TSN over 802.3cg (10 Mbps shared media) Status update (personal observations)

Craig Gunther
Craig Gunther Consulting, LLC
November 2018 IEEE 802 Plenary in Bangkok

Figure B.2—The RM for IEEE 802.3 point-to-point stations

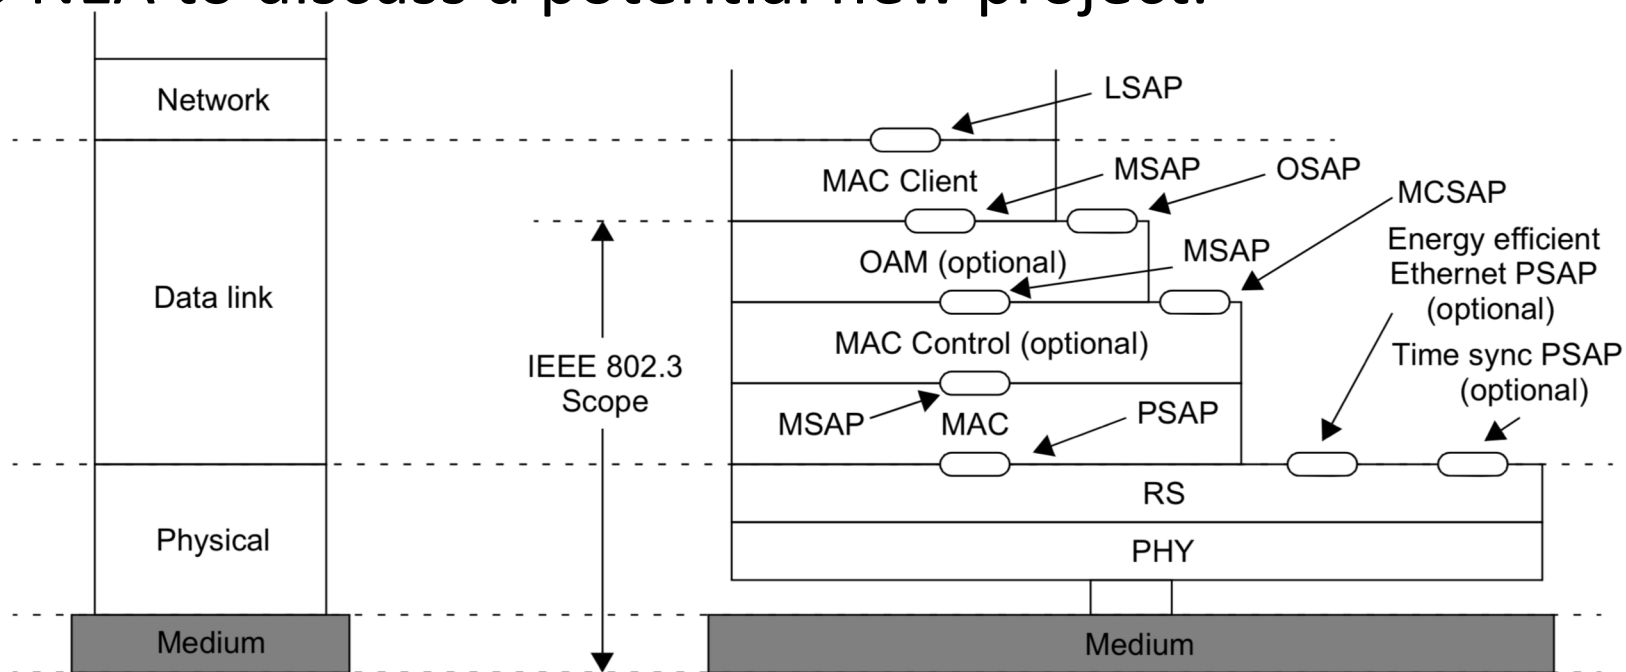
Oct 18, 802.3cg/D2.0 “[comment 573](#)” Ad hoc

Changes required to [pass priority/importance values](#) down through MSAPs and PSAP (802-2014 Figure B.2) are [not in scope](#) for 802.3cg. Move to NEA to discuss a potential new project.
